Executive Director's Recommendation

Commission Meeting: July 13, 2017

Terminal B/C Redevelopment, Secure National Hall, and New North Concourse - Ronald Reagan Washington National Airport

Metropolitan Washington Airports Authority

Comparison of Proposed North Concourse with Existing Hangars

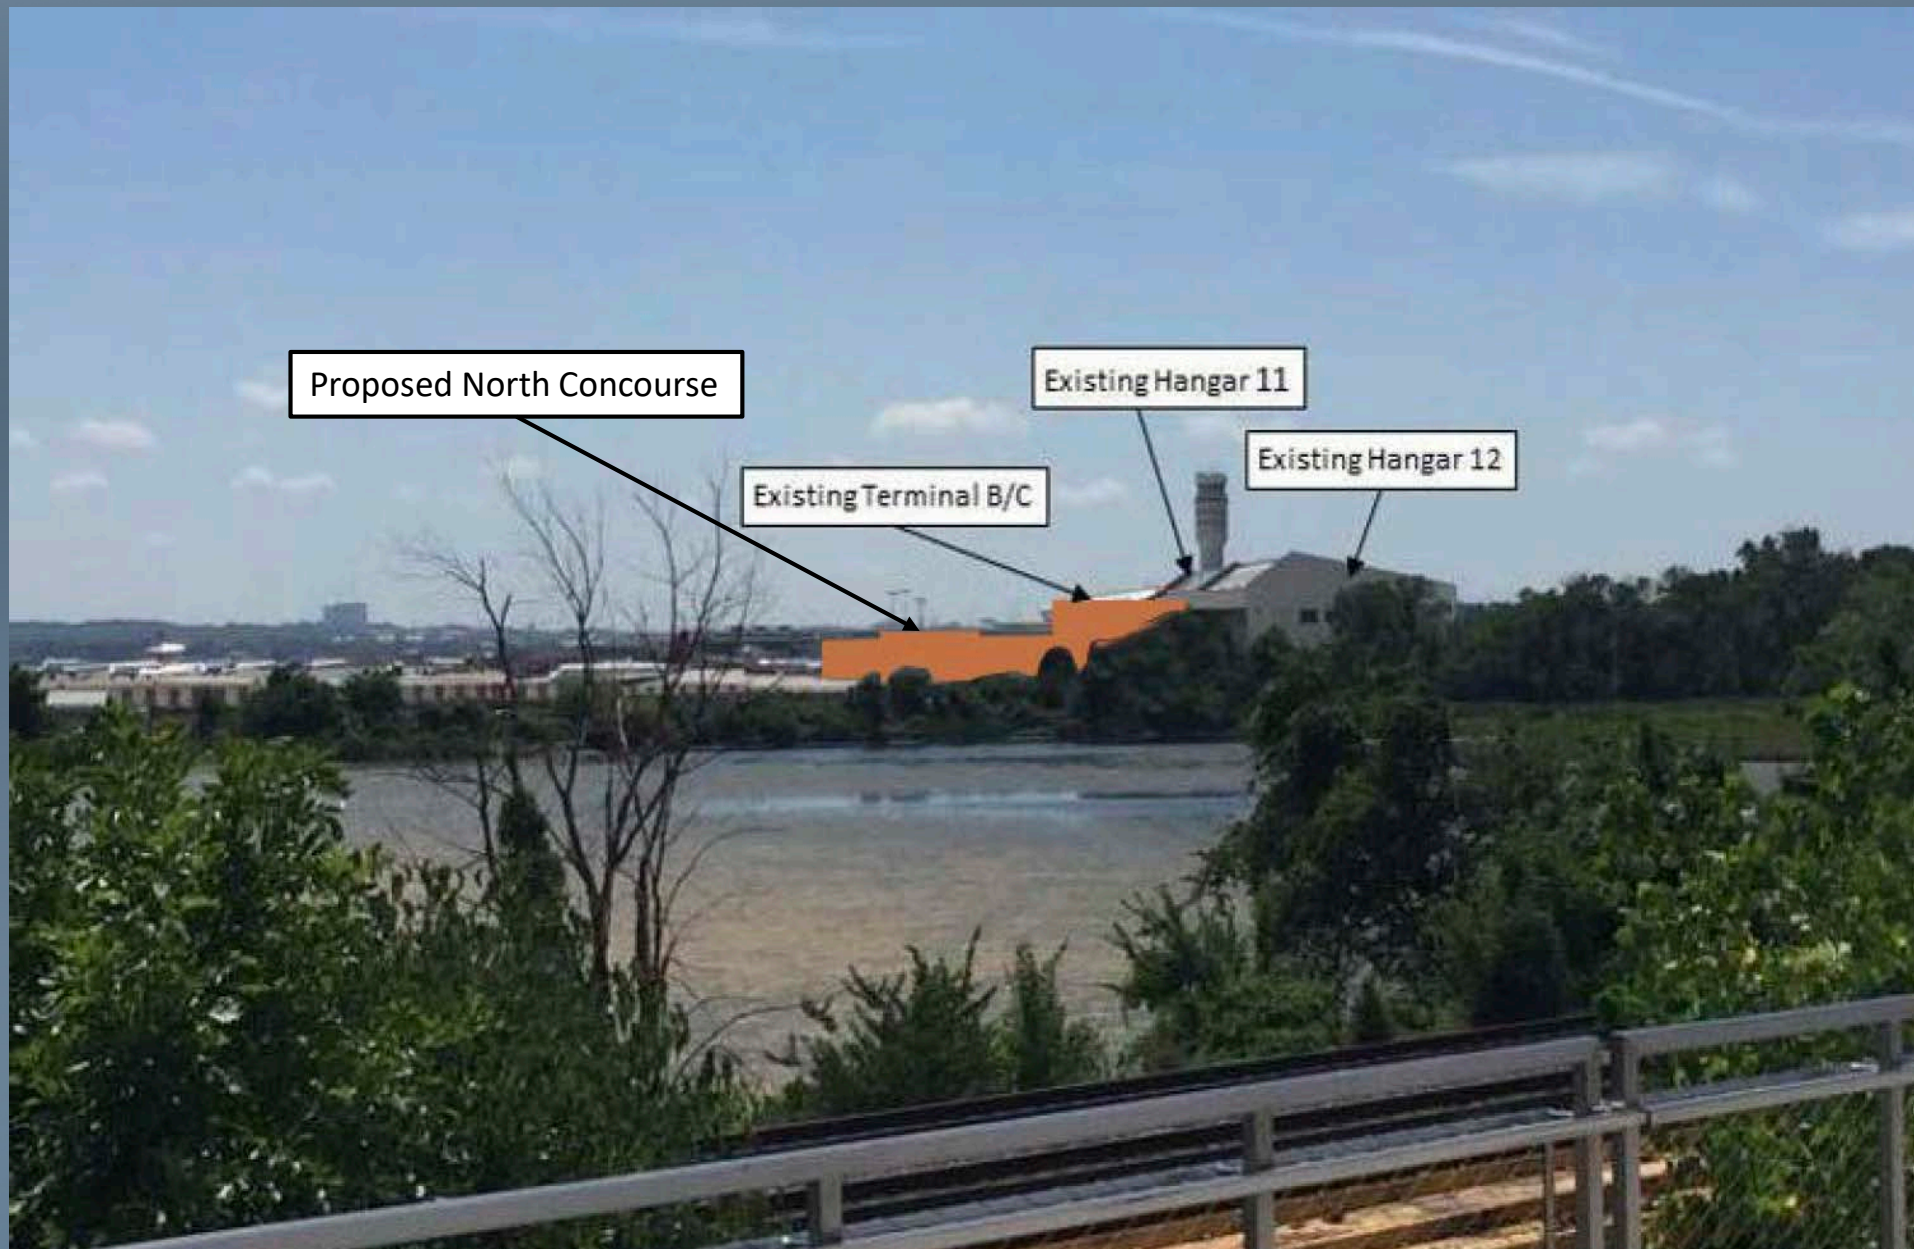
Today Reagan National Airport is very visible from East Potomac Park. Views include the different terminals to the east and the large hangars and central office building to the west. The proposal will improve this view by removing the large hangars and office building, opening up views to the George Washington Memorial Parkway and Roaches Run Wildlife Sanctuary in the background. The new North Concourse will be very visible as a new addition to the airport, however the pier itself will not be any taller than the existing concourse piers – the proposed project and existing terminals are both 48 feet in height. Photos of the existing airport at night demonstrate that it is very well lit in order to provide a safe nighttime environment for flights landing and departing the airport. The nighttime renderings show that there will not be a noticeable increase in overall lighting. The concourse will have the same lighting as the other concourses and the lighting associated with the hangars and office building will no longer exist with their removal.

Reagan National Airport is visible from the George Washington Memorial Parkway. As you approach the airport along the parkway from the north, the hangars and the office building are the most visible structures, blocking views of the runway, the planes, and the various concourses. Demolition of the large hangars and structures adjacent to the parkway and their replacement with the smaller North Concourse building will open up views toward the Potomac River and Gravelly Point to the east and north from the parkway.
